**75W Modification of Part 3A Concept
Plan Approval**

MP10_0159

Mixed Use Development

Royal Far West, Manly

Figure 12 – Building envelope and massing redistribution diagram (plan extract S75W – 1080)

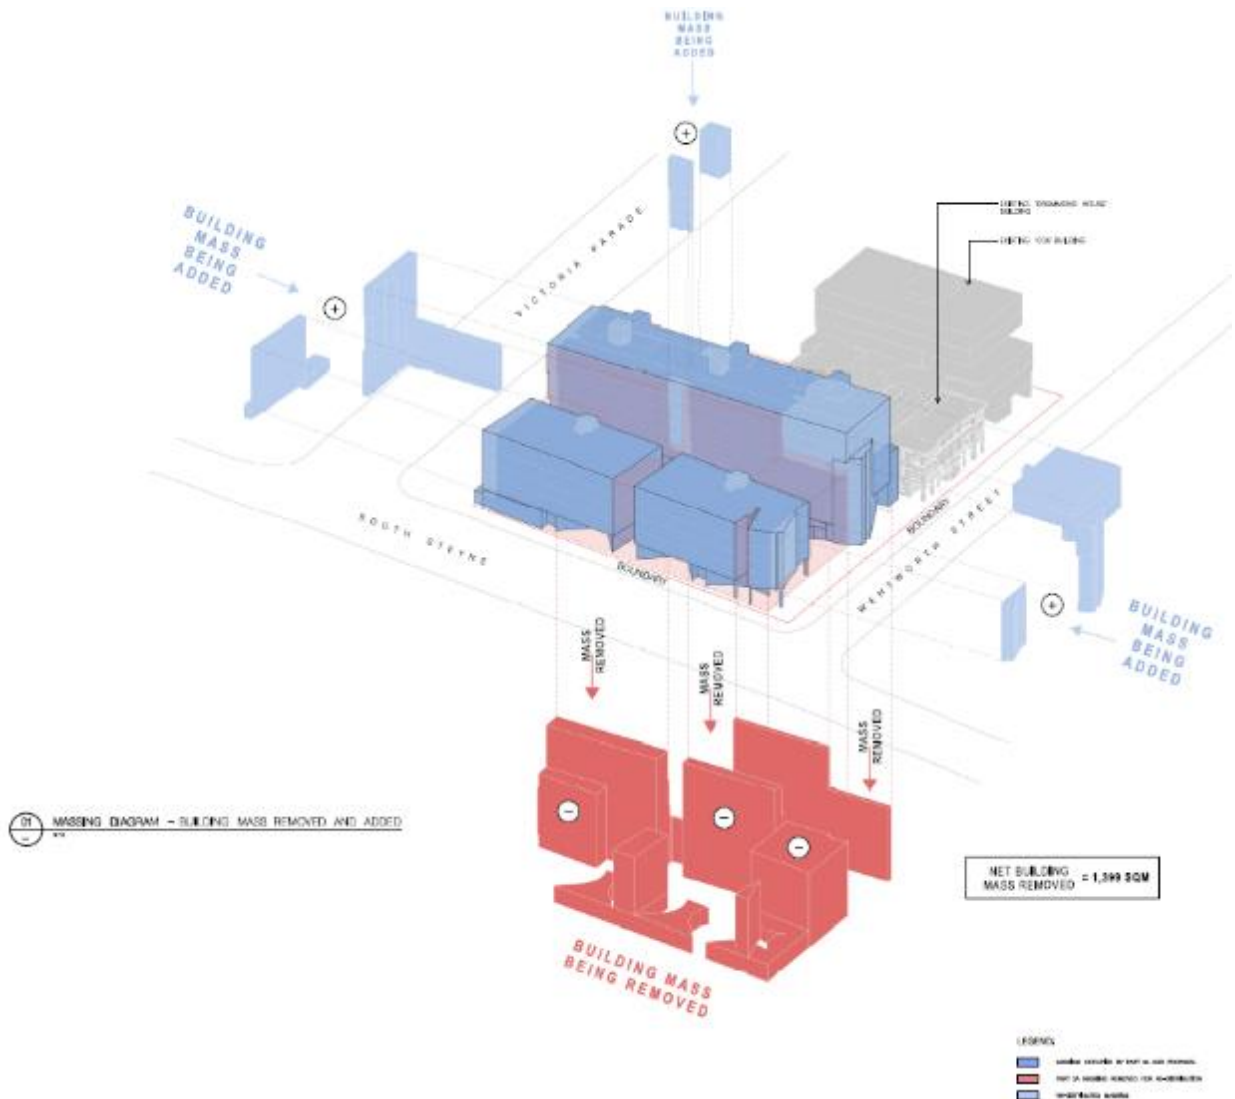
This application seeks to modify the approved building envelope and massing distribution as depicted in Figure 12 below.

- The previously approved 5 storey street wall to South Steyne is articulated through the creation of a partially open street level undercroft providing views and access to/ from the public forecourt, the provision of a central break in the facade and the introduction of a building envelope articulation zone at the intersection of South Steyne and Wentworth Street.
- The previously approved ground level retail floor space is redistributed around the publicly accessible forecourt whilst maintaining retail activation of both the Wentworth Street and South Steyne frontages as depicted in Figure 13 below.

Figure 14 – Building envelope and massing redistribution streetscape diagram (plan extract S75W – 1354)

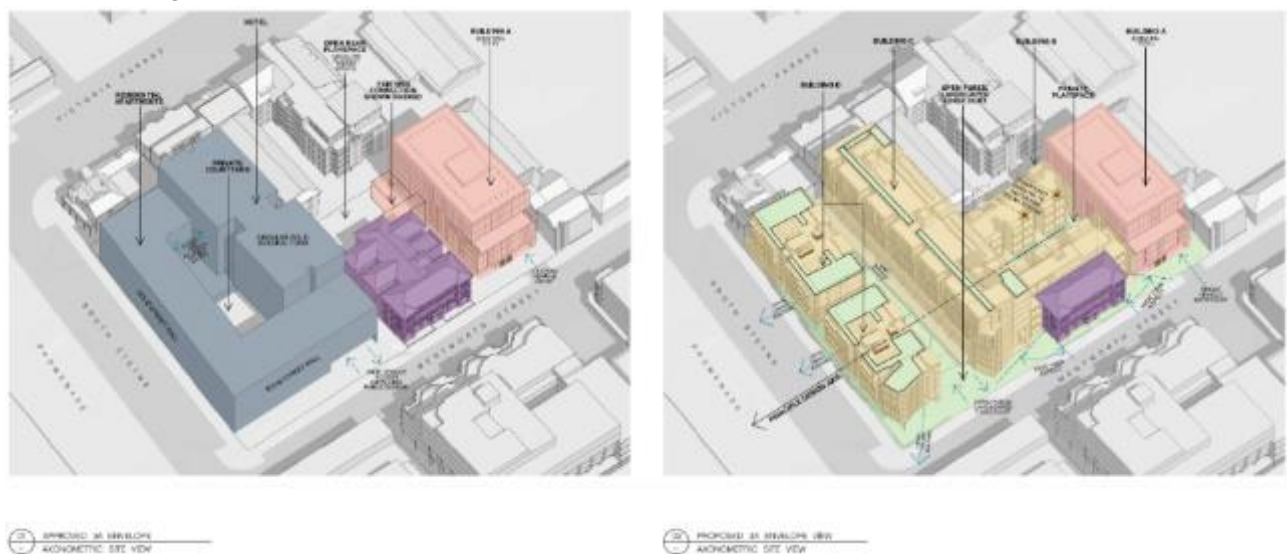
- The floor space removed as a consequence of the above modifications is redistributed to the southern and northern edges of the approved building envelope and to the rear of Drummond House the rear portion of which is proposed to be demolished. A comparison of the approved and modified building envelope and massing is depicted at Figure 14 below.

Figure 16 – Proposed building heights (plan extract S75W – 1012)

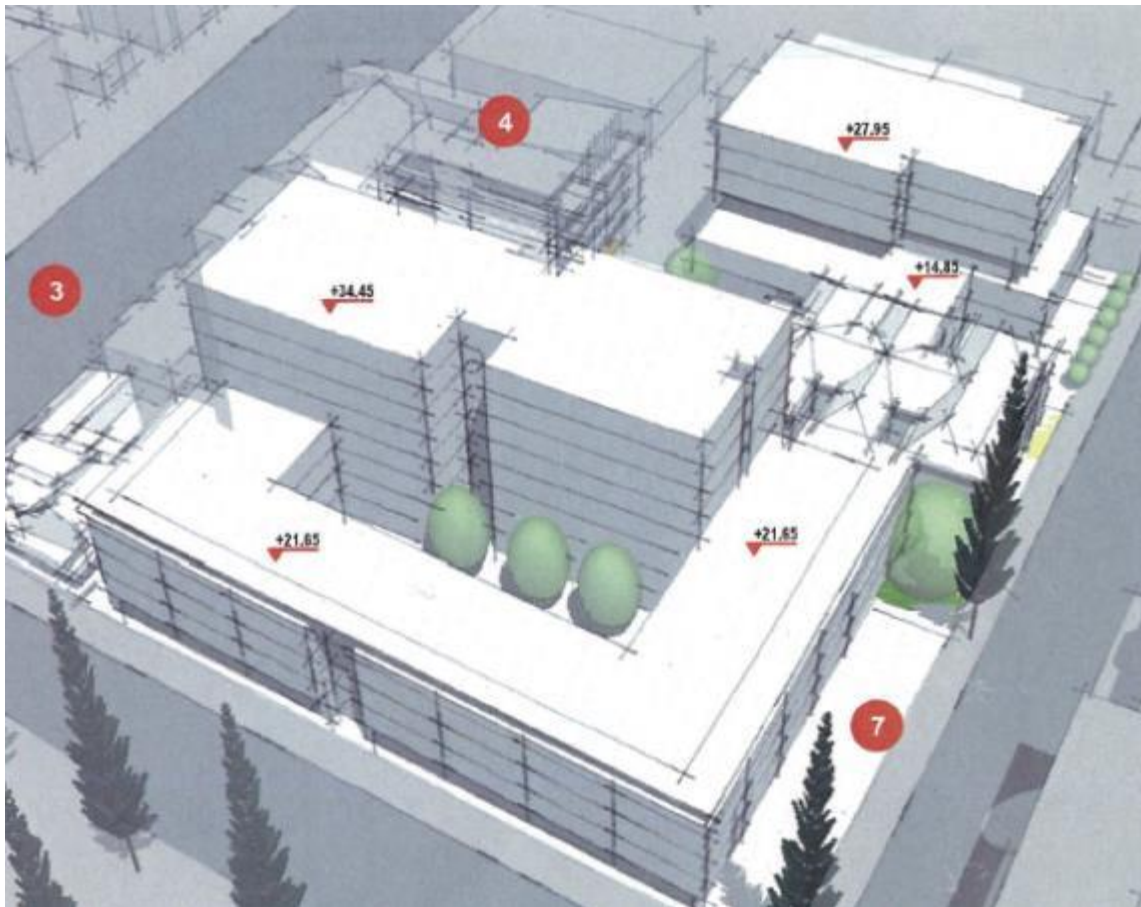
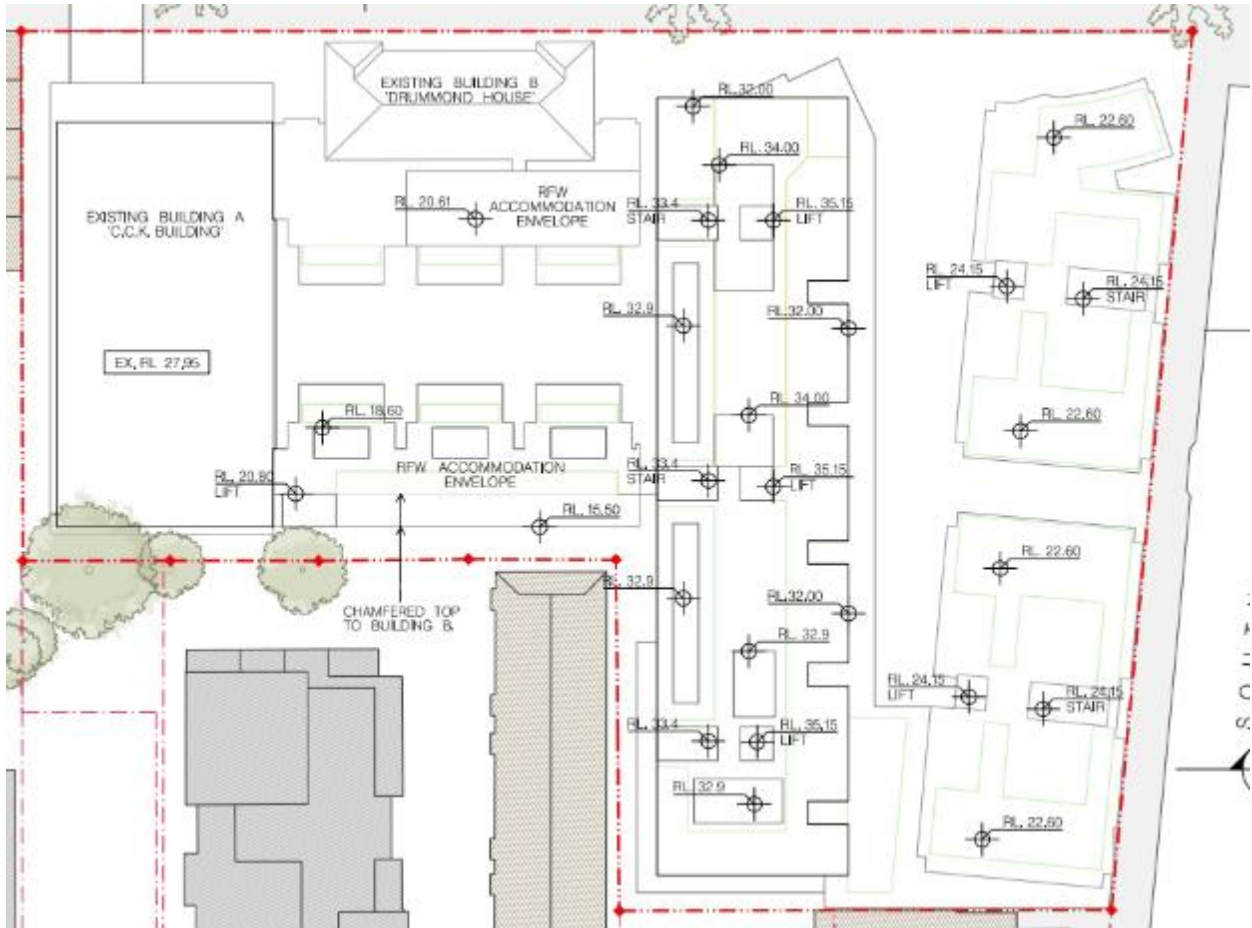
- The previously approved part 5/ part 8 storey building height envelope and massing outcome for the site is maintained with the modified envelope accommodating an FSR below 3:1 as required by the Concept Approval.

- Overall building heights are modified to reflect compliance with the minimum floor to floor heights contained within the ADG, the introduction of landscaped roof top communal and private open space areas on Buildings C and D, associated shading structures and the provision of sufficient height allowance to accommodate associated lift and stair access and mechanical plant enclosures.

- The previously approved and modified overall building heights are depicted in Figures 15 and 16 below and over page.

Figure 17 – Basement 2 comparative diagrams (plan extract S75W – 1001)

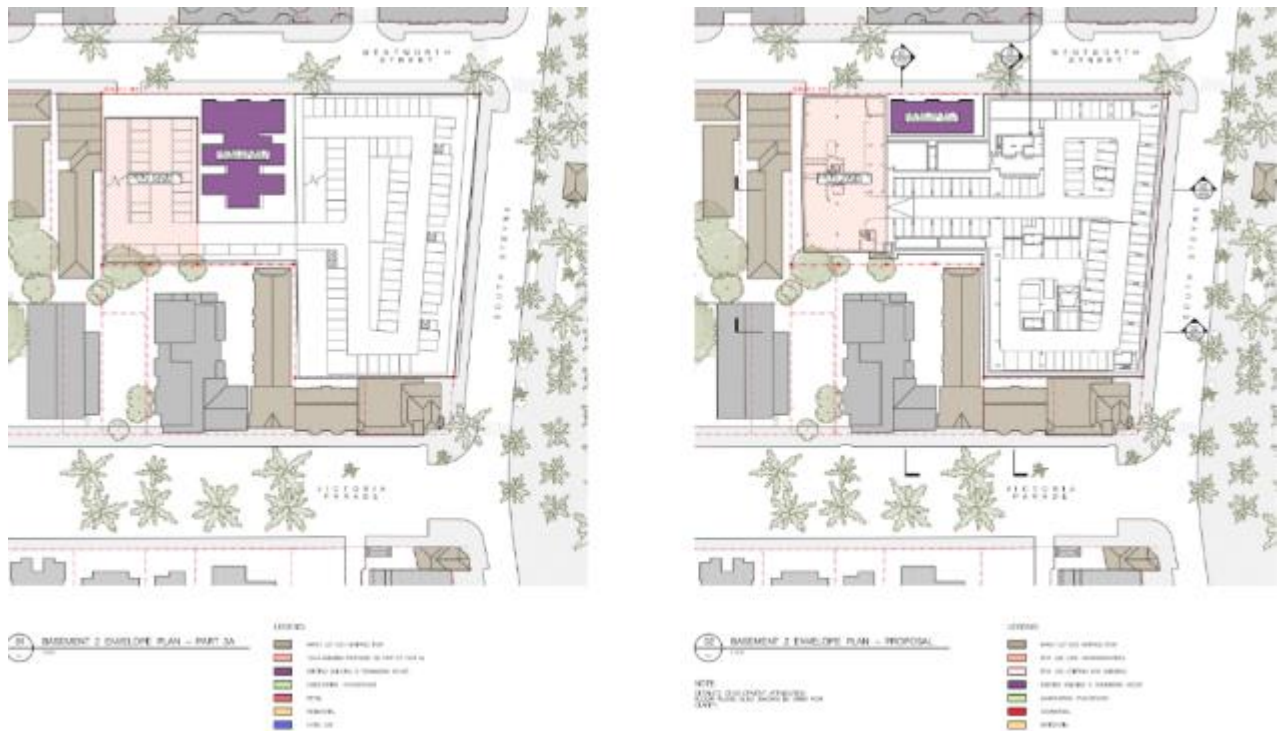
- The PAC required the previously nominated hotel use to be replaced with tourist and visitor accommodation. Such accommodation is nominated as “RFW Use (New Accommodation)”,
- The basement below the constructed CCK building is depicted “as built”,
- The basement is reconfigured to reflect the modified Drummond House building footprint,
- The basement is extended to the western boundary of the site where it adjoins No. 25 – 29 Victoria Parade to improve basement layout efficiencies. The basement geometry and the extent of approved excavation is otherwise unaltered, and

- An indicative basement arrangement has been nominated although we note that the final layout will be detailed at Development Application (DA) stage it being noted that both basement levels provide for not less than 184 car spaces as required by Condition 10 at Schedule 3 of the Approval Instrument.

Figure 18 – Basement 1 comparative diagrams (plan extract S75W – 1002)

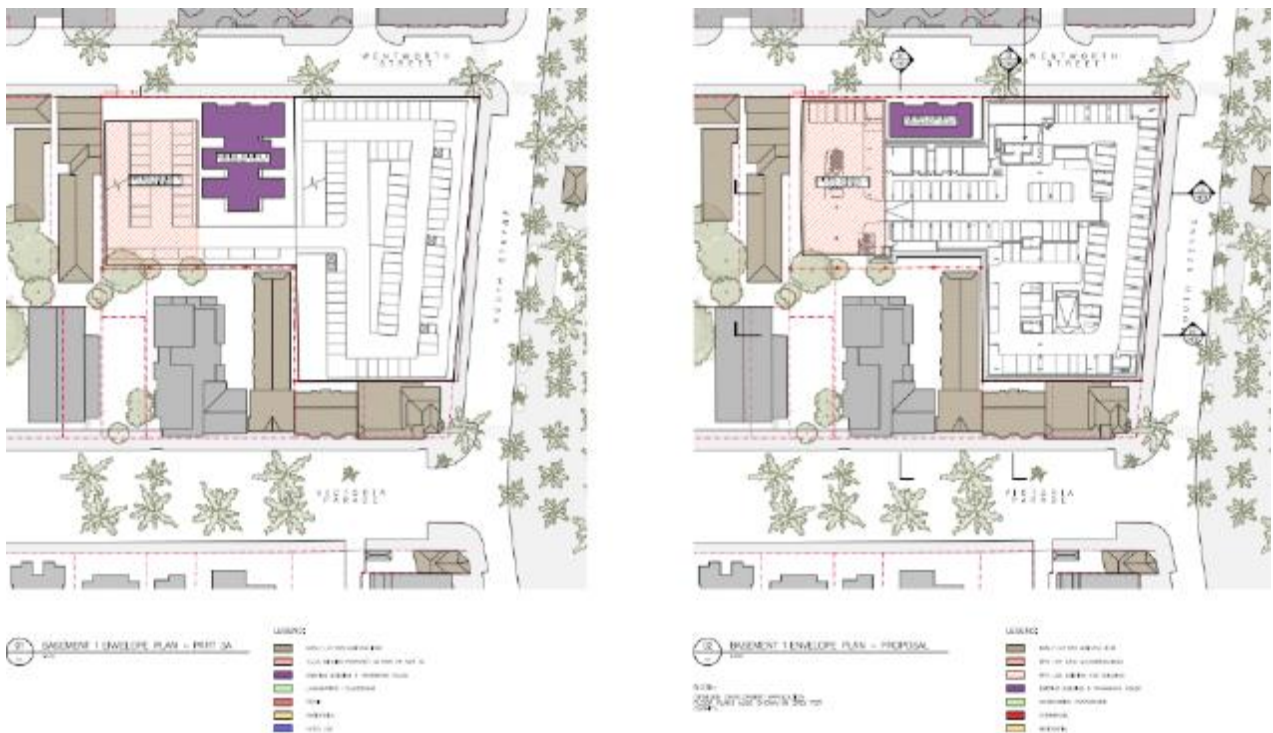
- The basement below the constructed CKK building is depicted “as built”,
- The basement is reconfigured to reflect the modified Drummond House building footprint,
- The basement is extended to the western boundary of the site where it adjoins No. 25 – 29 Victoria Parade to improve basement layout efficiencies. The basement geometry and the extent of approved excavation is otherwise unaltered, and

- An indicative basement arrangement has been nominated although we note that the final layout will be detailed at Development Application (DA) stage it being noted that both basement levels provide for not less than 184 car spaces as required by Condition 10 at Schedule 3 of the Approval Instrument.

Figure 19 – Ground Level comparative diagrams (plan extract S75W – 1003)

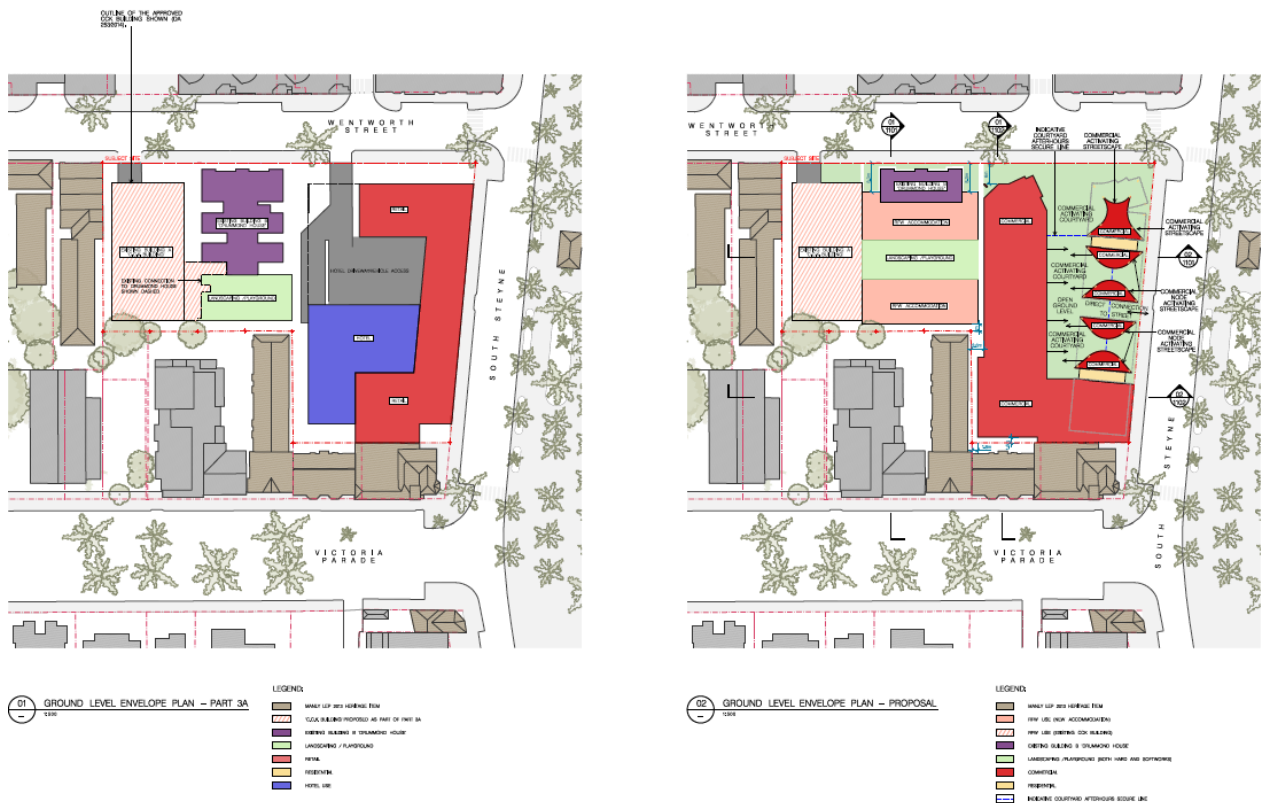
- The publicly accessible forecourt will be secured outside normal business hours with an indicative secure line nominated on the plan.
- The previously approved setbacks to Wentworth Street and South Steyne are generally maintained with a 6 metre setback maintained to Wentworth Street where the commercial floor plate adjoins Drummond House and an 8.3 metre front setback maintained to the new RFW accommodation to the rear of Drummond House, and

Figure 20 – Level 1 comparative diagrams (plan extract S75W – 1004)

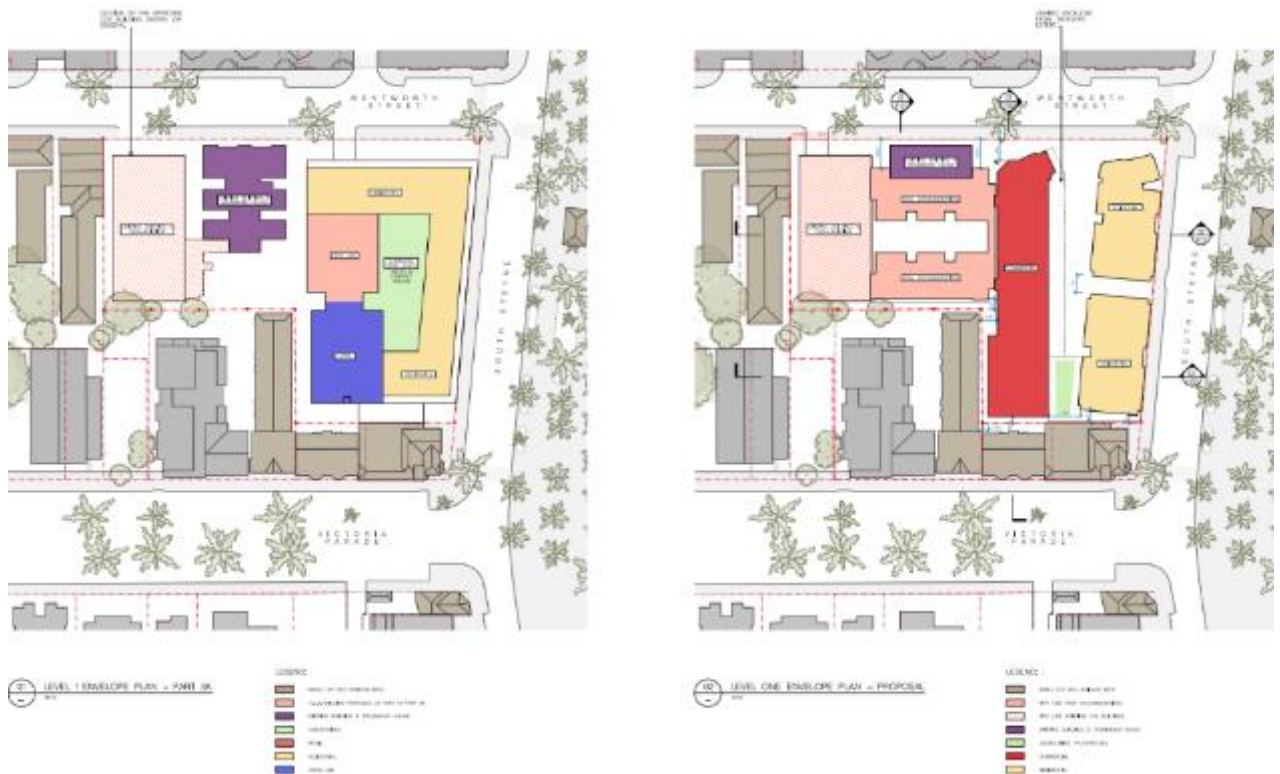
- The previously approved podium level communal open space is relocated to the roof of Building C,
- The previously nominated hotel and RFW uses are consolidated into a single commercial floor plate to the west of the publicly accessible forecourt area,

- The residential floor space is redistributed and broken into 2 pavillions located adjacent to the South Steyne frontage,
- The rear portion of Drummond House is demolished and replaced with RFW guest accommodation orientated towards a centrally located private and secure courtyard.
- The previously approved setbacks to Wentworth Street and South Steyne are generally maintained with a 6 metre setback maintained to Wentworth Street where the commercial floor plate adjoins Drummond House and an 8.3 metre front setback maintained to the new RFW accommodation to the rear of Drummond House, and
- The residential and commercial floor plates are extended towards the southern and western boundaries of the properties with the previously approved building envelope, where it adjoins the southern boundary, broken to provide for a continuation of the central forecourt space.

Figure 21 – Level 2 comparative diagrams (plan extract S75W – 1005)

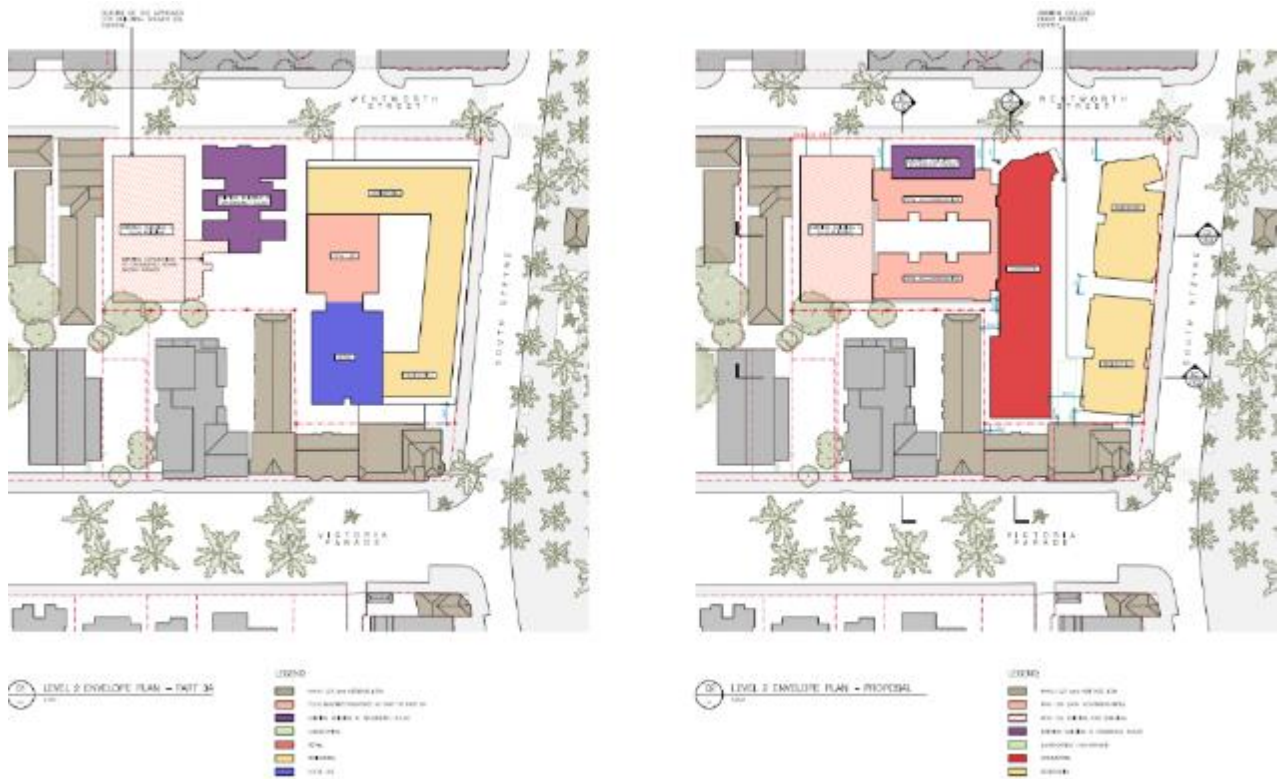
The modifications at this level are the same as those associated with Level 1.
